AMENDMENTS TO THE DRAWINGS

Appln. No. 09/552,590
Amend. Dated: 3/18/04
Reply to Office Action of 12/19/03
Replacement Sheet

FIG. 1

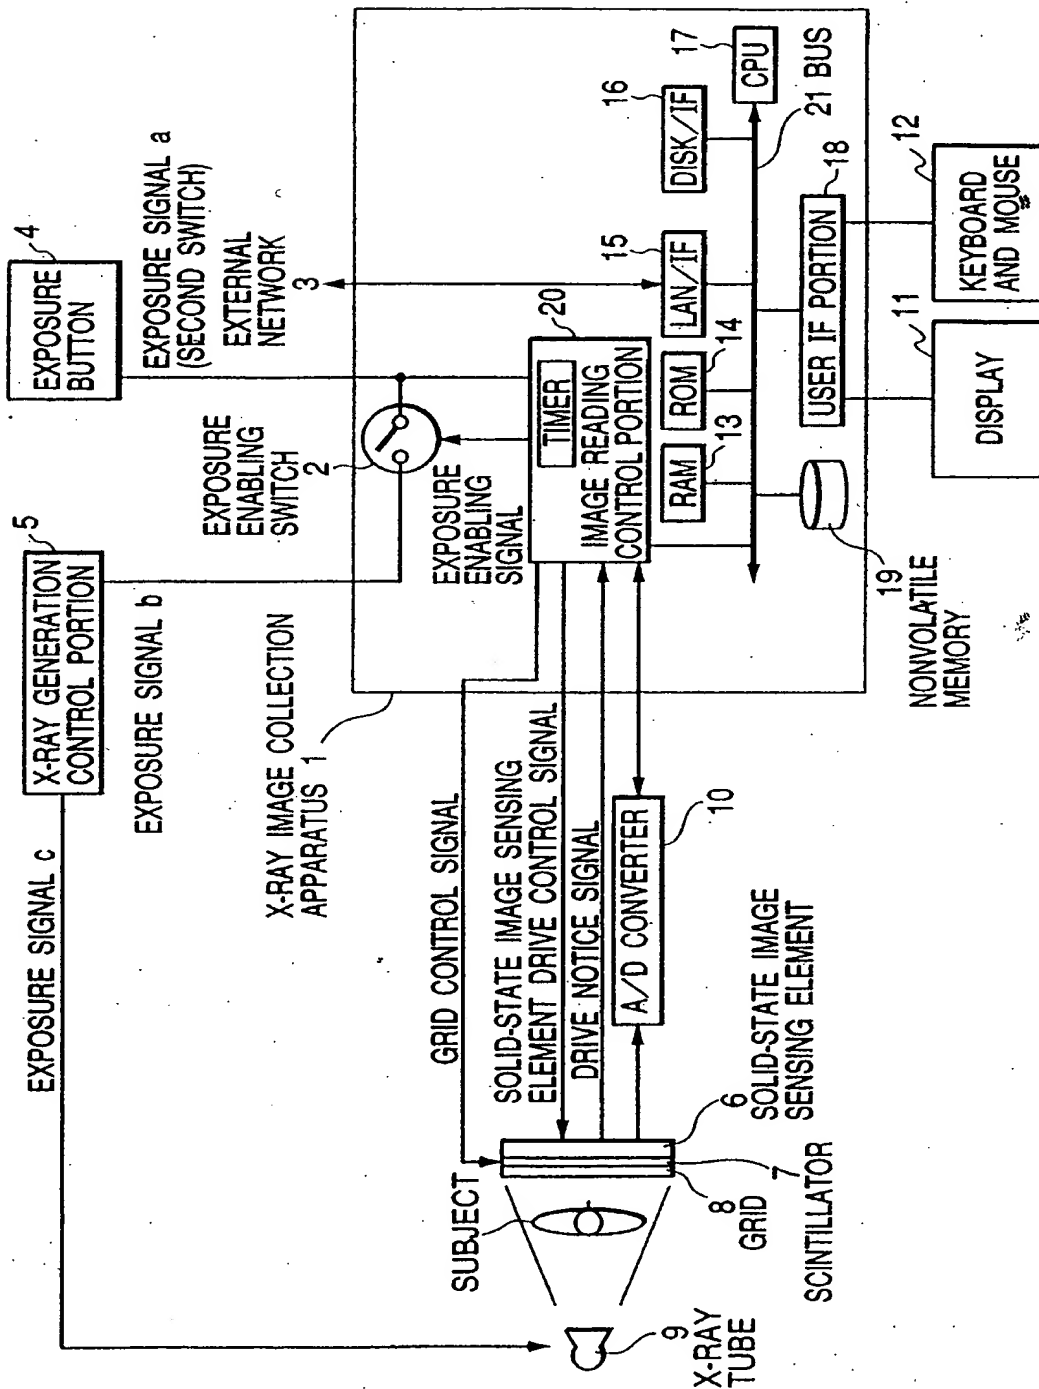
Fig. 1, change "X-RAY GENERATOR CONTROL PORTION" to --X-RAY GENERATION CONTROL PORTION--, change "IMAGE READ CONTROL UNIT" to --IMAGE READING CONTROL PORTION--, change "EXPOSURE ENABLING SWITCH 10" to --EXPOSURE ENABLING SWITCH 2--, and delete "EXTERNAL PORTABLE STORAGE MEDIUM 2".

FIG. 2

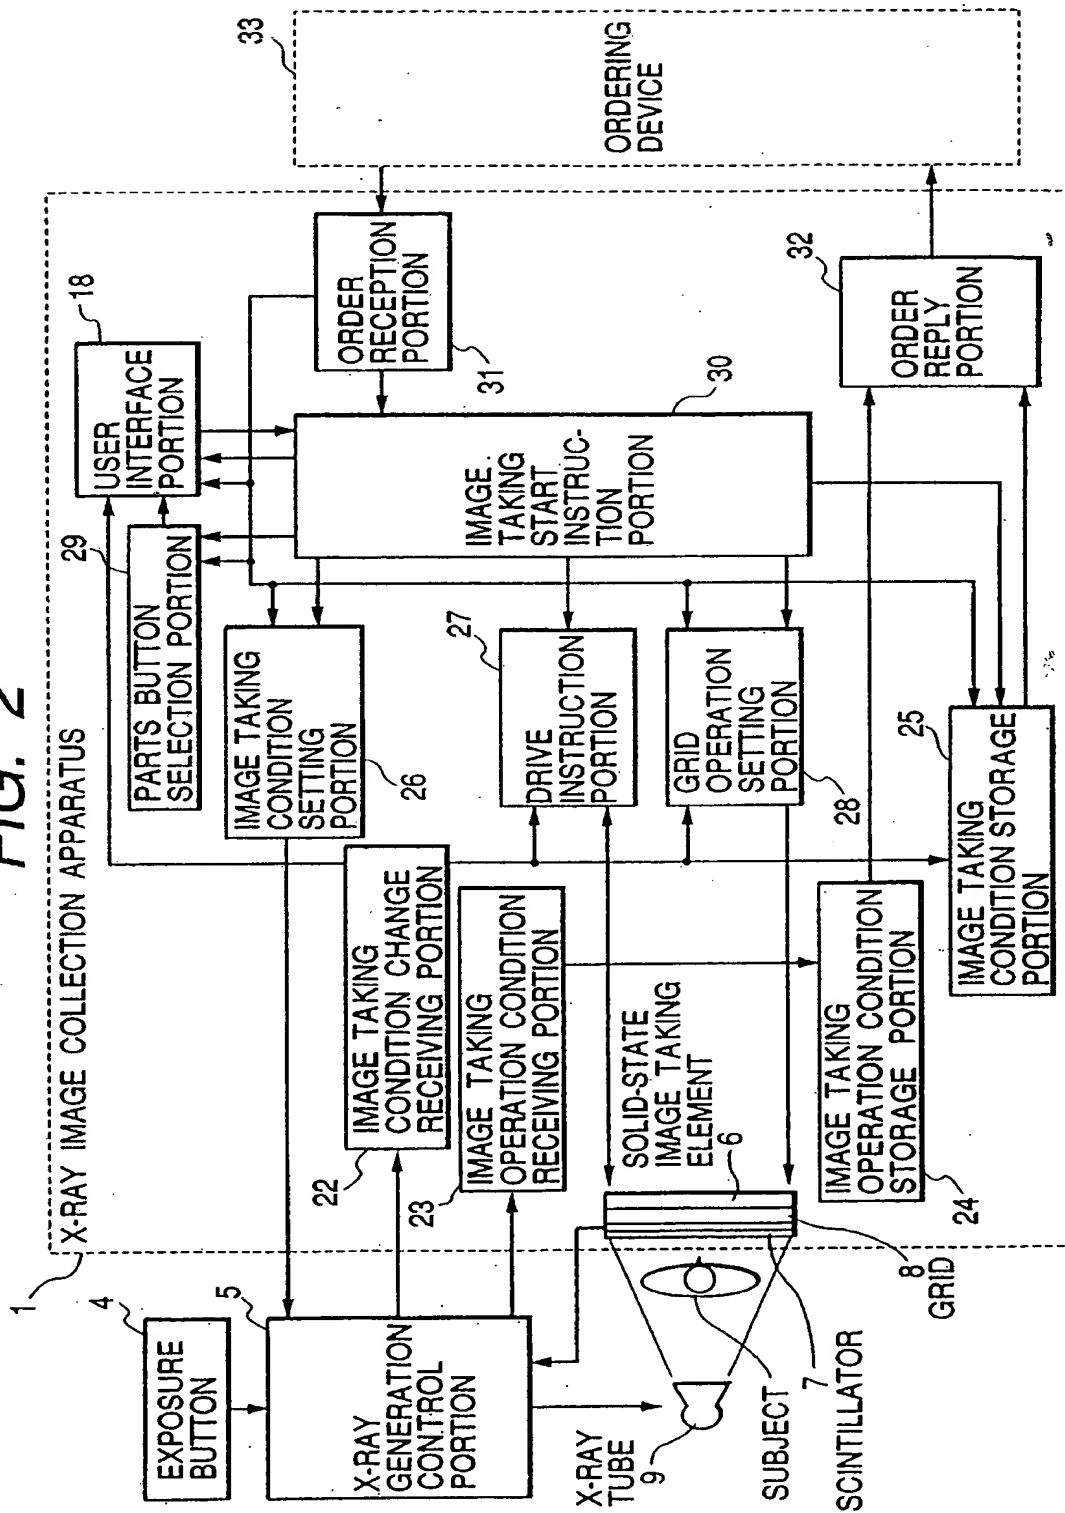
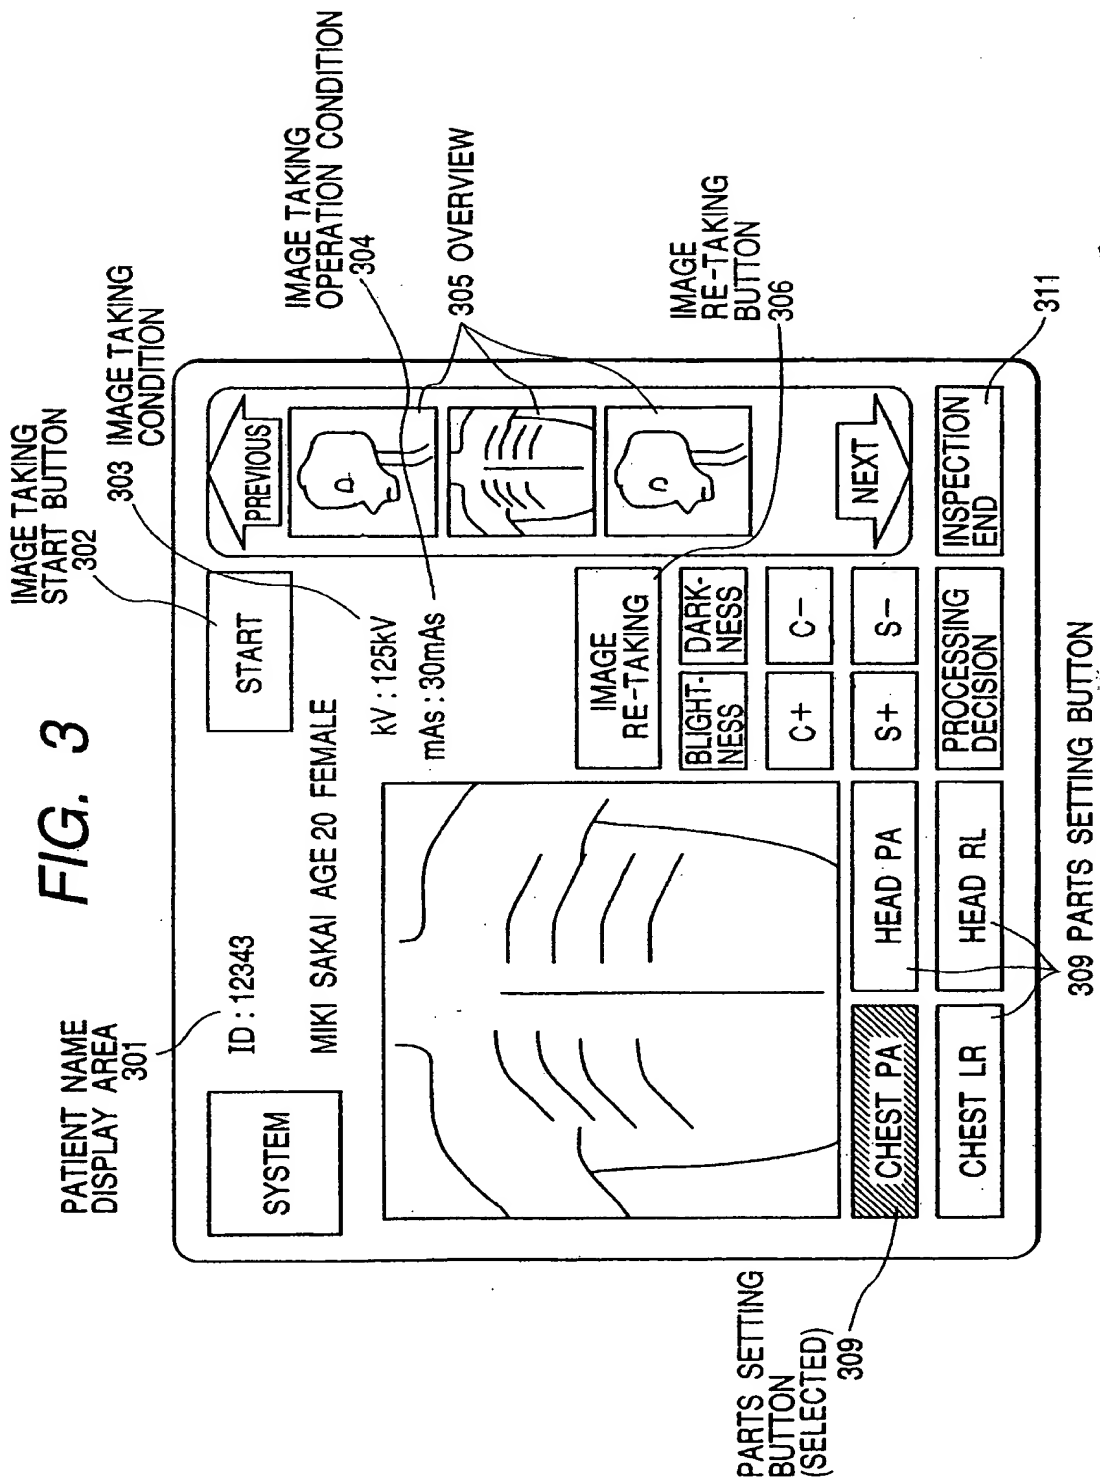
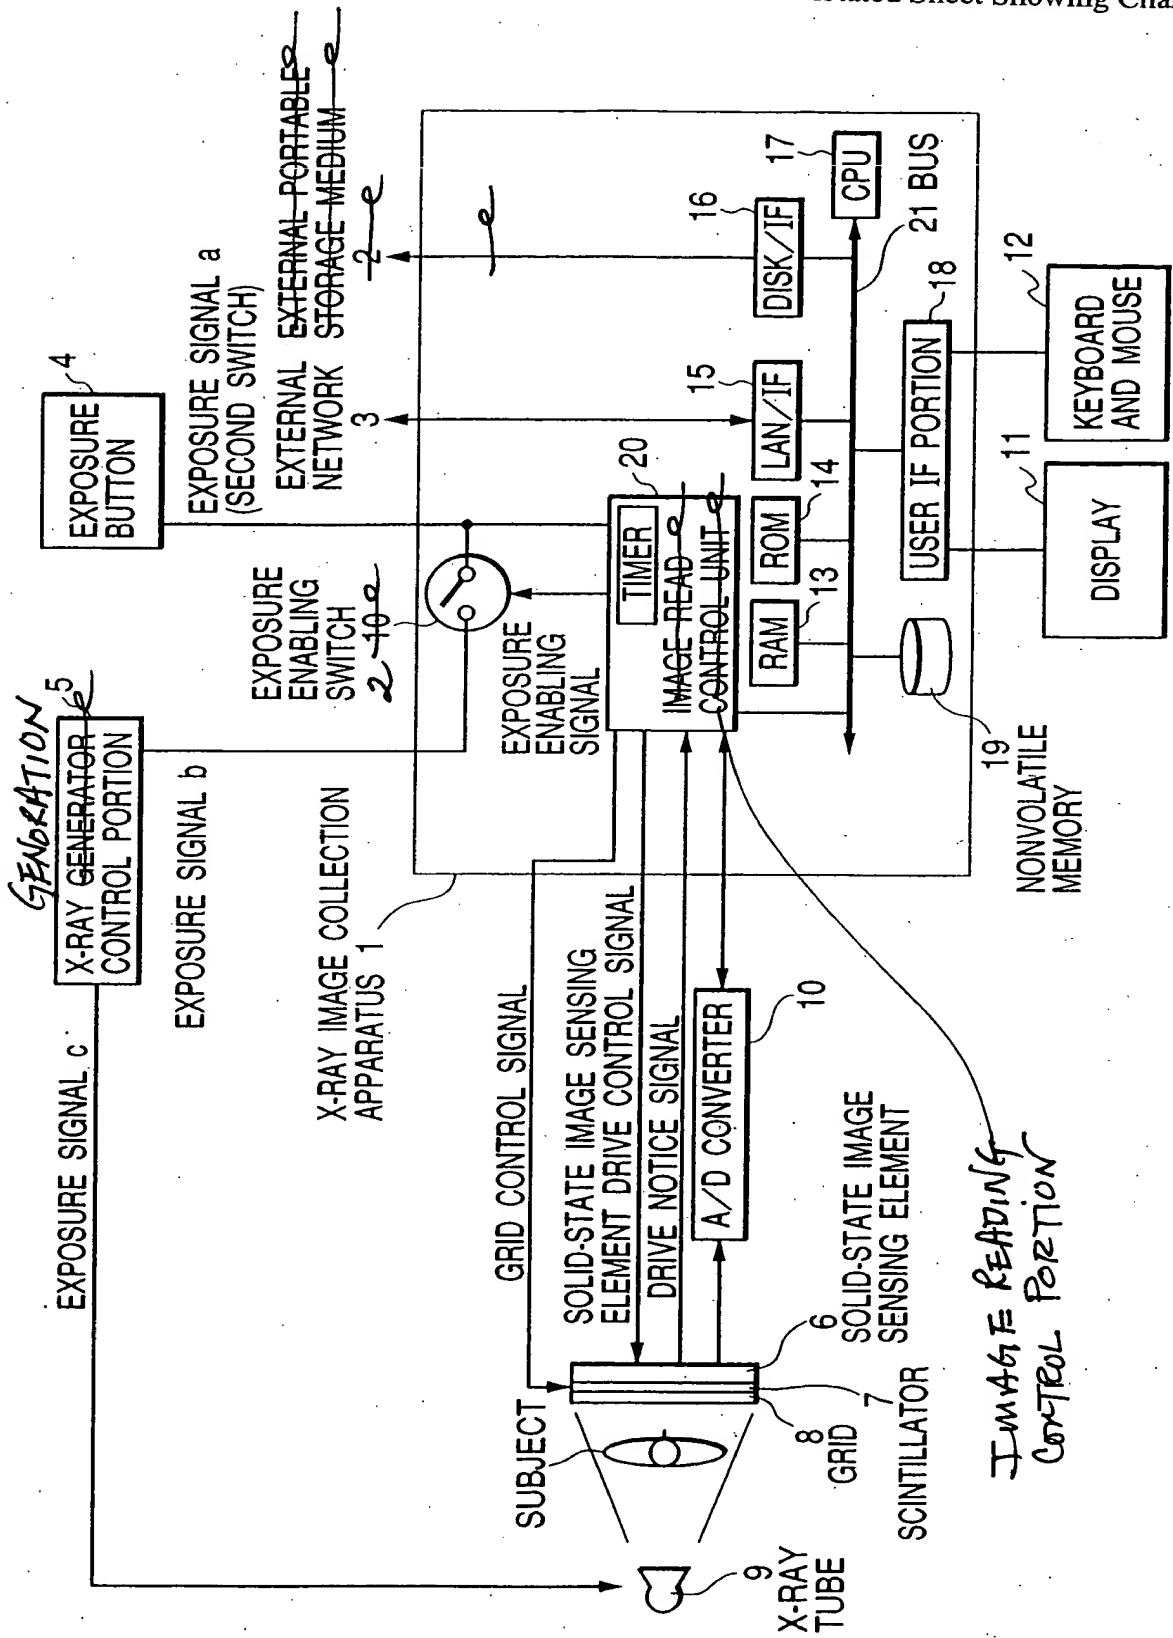
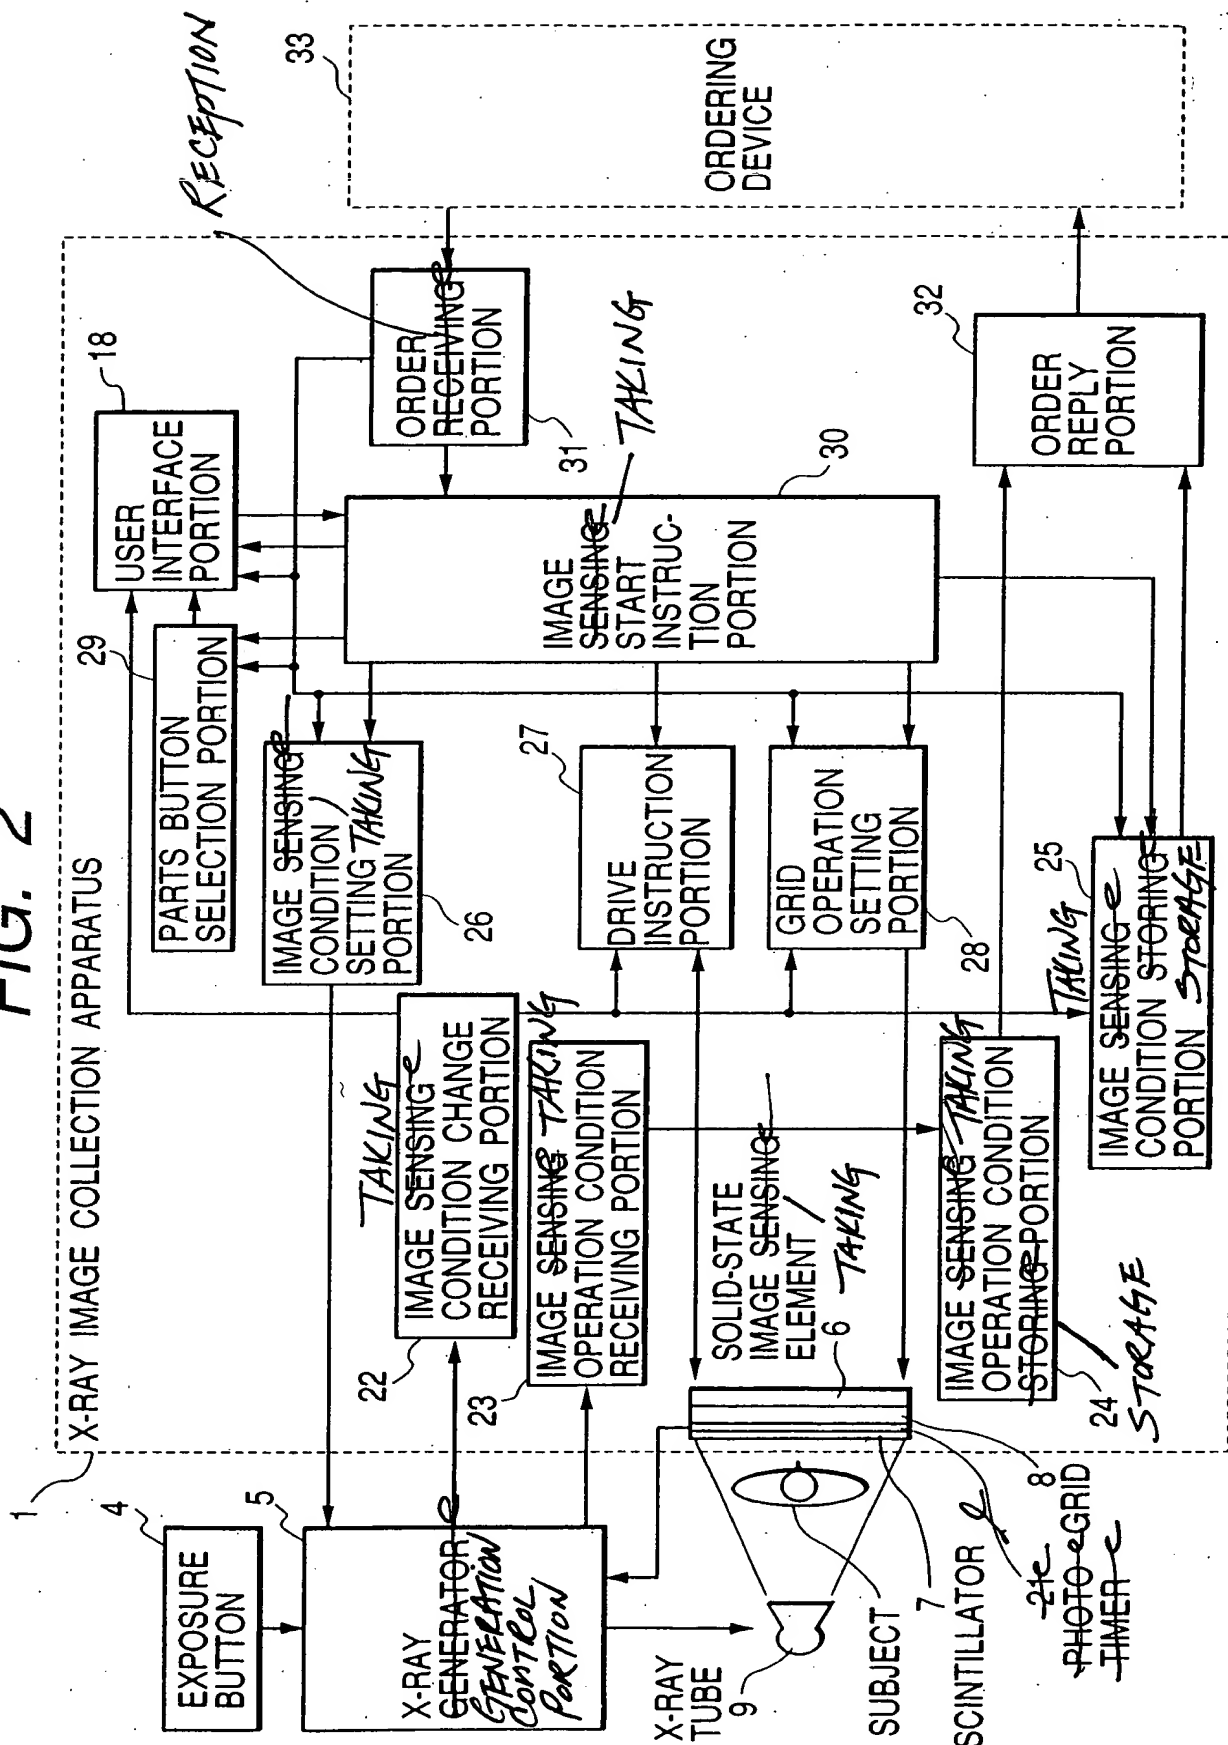
Fig. 2, change "X-RAY GENERATOR" to --X-RAY GENERATION CONTROL PORTION--, change "IMAGE SENSING CONDITION CHANGE RECEIVING PORTION" to --IMAGE TAKING CONDITION CHANGE RECEIVING PORTION--, change "IMAGE SENSING OPERATION CONDITION RECEIVING PORTION" to --IMAGE TAKING OPERATION CONDITION RECEIVING PORTION--, change "SOLID-STATE IMAGE SENSING ELEMENT" to --SOLID-STATE IMAGE TAKING ELEMENT--, change "IMAGE SENSING OPERATION CONDITION STORING PORTION" to --IMAGE TAKING OPERATION CONDITION STORAGE PORTION--, change "IMAGE SENSING CONDITION STORING PORTION" to --IMAGE TAKING CONDITION STORAGE PORTION--, change "IMAGE SENSING CONDITION SETTING PORTION" to --IMAGE TAKING CONDITION

SETTING PORTION--, change "IMAGE SENSING START INSTRUCTION PORTION" to --IMAGE TAKING START INSTRUCTION PORTION--, change "ORDER RECEIVING PORTION" to --ORDER RECEPTION PORTION--, and delete "21 PHOTO TIMER".
